**Re: TransCanada Keystone Pipeline GP Ltd. ("Keystone")
Certificate OC-51
Line 100-1 Engineering Assessment Addendum – Mitigation Plan
NEB File: NEB File: OF-Fac-Oil-T241-2006-01-02**

4. Deterministic Analysis of Critical Defects

Figure 5

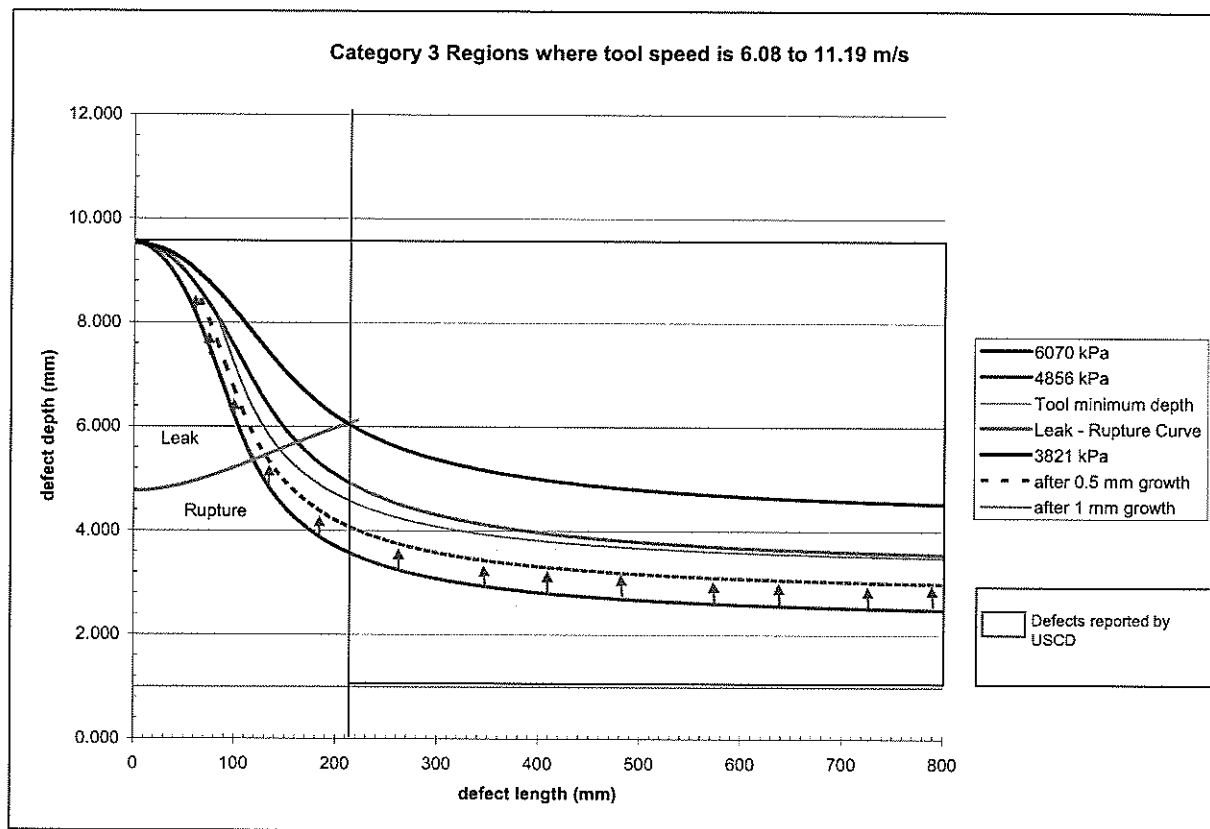
The sentence plot in Figure 5 is for Category 3 sections. The pressures (with critical crack sizes) represented are:

- 6,070 kPa which is the pressure at which the gas service was provided in 2009
- 4,856 kPa which is the reduced maximum pressure that these sections will be operated at
- 3,821 kPa which is the maximum operational pressure that the Category 3 sections will experience during the first 9 months of commercial operation

Consequently any defects that are at or above the 6,070 kPa critical size line will not exist in the pipeline in 2009. These are the remaining defects after gas operation and are shown illustratively in Figure 5 as red stars. The remaining defects below the 6,070 kPa line can grow in size before the next CDILI and mitigation. Therefore the 6,070 kPa line has been grown by 0.5 and 1 mm in depth. The rationale for the growth value is given above.

All defects that could exist on the pipeline in 2010 before the next CDILI and mitigation are below the growth lines. As the growth lines are completely below the 4,856 kPa line and well below the actual operational line of 3,821 kPa for Category 3, a safety factor of more than 2.0 is noted for growth. Therefore with new mitigative operational pressures even without considering the CDILI run there is a large margin of safety.

Considering the maximum tool velocity achieved during inspection all critical defects greater than 215 mm length will have been detected. This flaw length is at the leak rupture boundary of 3,821 kPa. Therefore for all over-speed sections running at the reduced pressures dictated by the mitigation plan, any defect that could rupture would have been detected by the ILI tool. This shows that even in the worst over-speed areas, the minimum detectable flaw length is large enough to detect the smallest flaw that could rupture at the planned operating condition.

The defects that are shorter than 215 will lead to leaks but they too have an acceptable margin of safety considering the previous higher gas operational pressures.

Figure 6
Analysis of critical defects in Category 2 regions

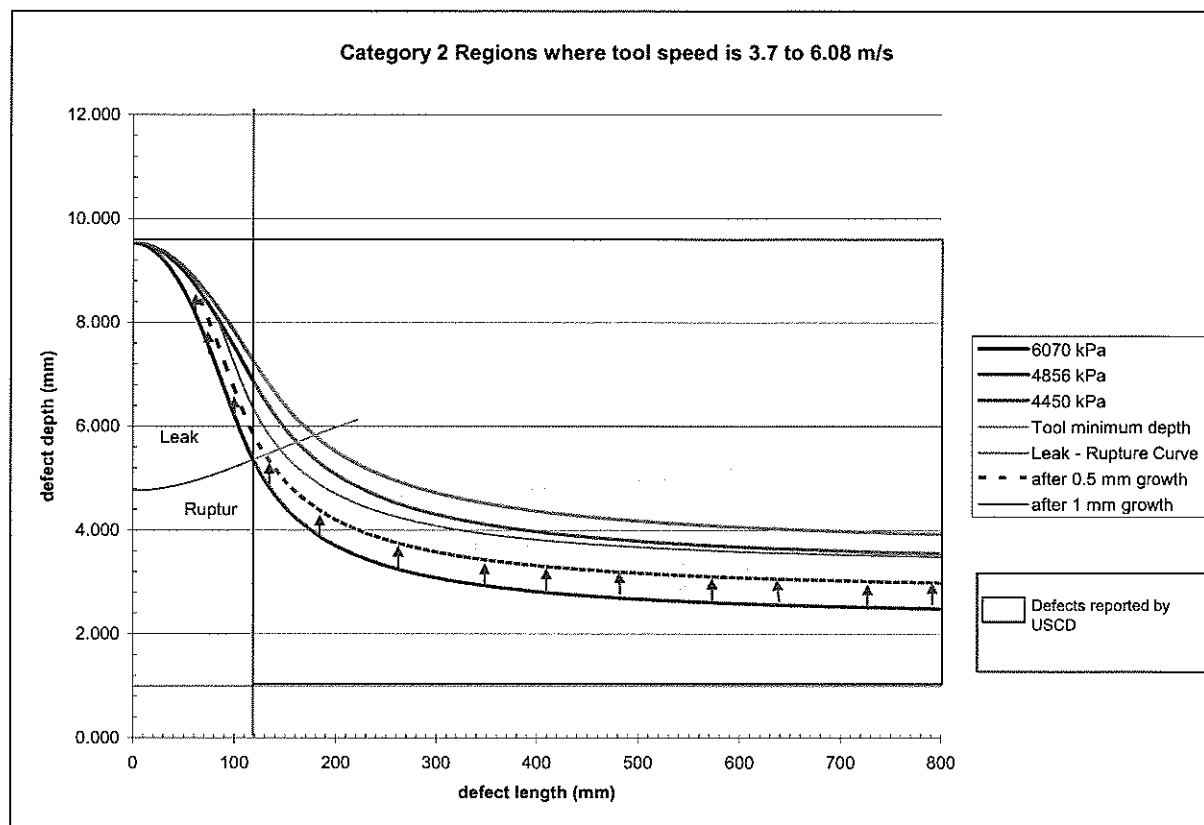
The following sentencing plot is for Category 2 sections. The pressures (with critical crack sizes) represented are 6,070, 4,856 and 4,450 kPa. The Category 2 sections see a maximum pressure of 4,450 kPa. Similar to what was described in Section 4.1, 6,070 kPa is the pressure at which this pipeline operated in gas service prior to 2009. The 6,070 kPa line and the growth lines are shown. Because the growth lines are well below the 4,450 kPa line no existing defects will become critical within the first 9 months of commercial operation.

Considering the tool velocity in this region all defects that could rupture are well within the tool detection capability. This shows that in Category 2, the minimum detectable flaw size is sufficient to detect the smallest flaw that could rupture at the planned operating condition.

The defects that are shorter than 120 mm will lead to leaks but they too have an acceptable margin of safety considering the previous higher gas operational pressures.

Figure 7

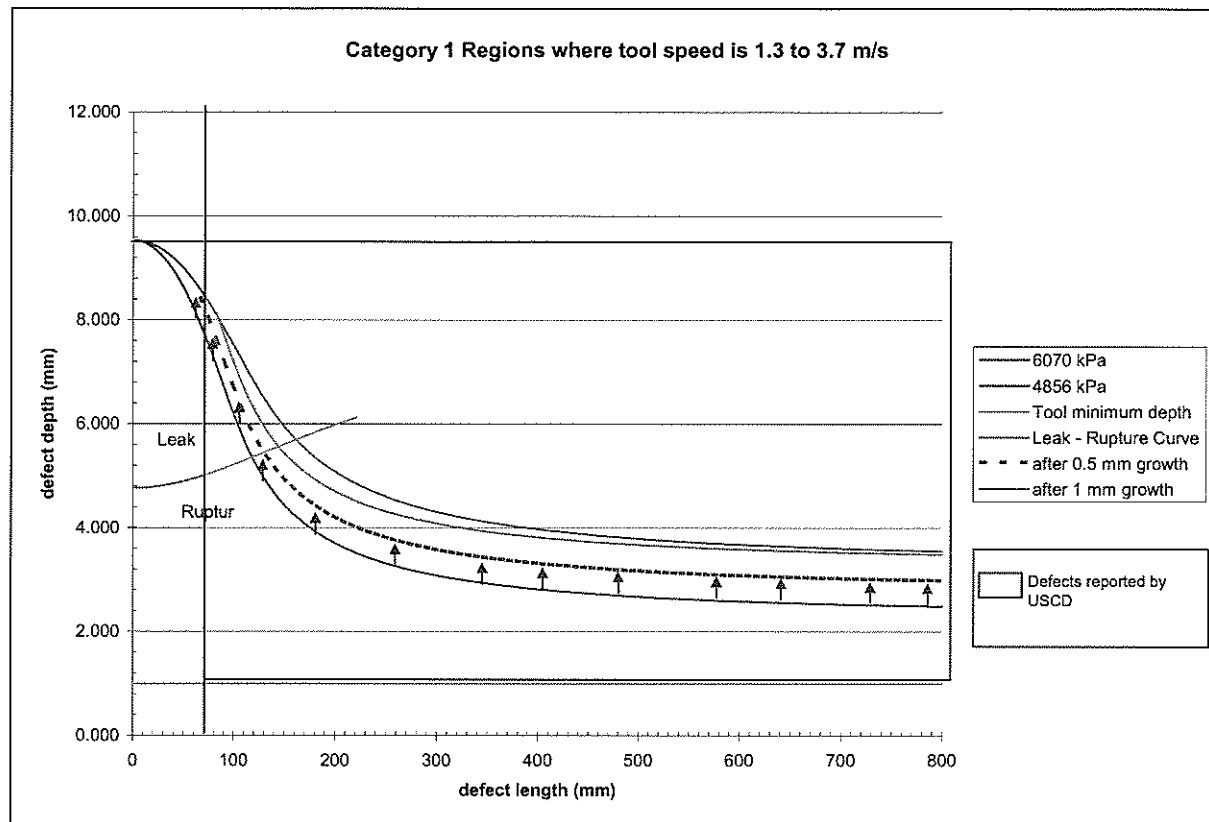
The following sentencing plot is for Category 1 sections. The pressures (with critical crack sizes) represented are 6,070 and 4,856 kPa. Because some sections of Category 1 areas run at the new maximum operating pressure that is the maximum pressure used for Category 1. Similar to what was described in Section 4.1, 6,070 kPa is the pressure at which this pipeline operated in gas service prior to 2009. The 6,070 kPa line and the growth lines are shown below. Because the growth lines are well below the 4,856 kPa line, no existing defects will become critical within first 9 months of commercial operation.

Considering the tool velocity in this region all defects that could rupture are well within the tool detection capability. This shows that in Category 1, the minimum detectable flaw size is sufficient to detect the smallest flaw that could rupture and cause large leaks at the planned operating condition.

The defects that are shorter than 72 mm will lead to leaks but they too have an acceptable margin of safety considering the previous higher gas operational pressures.
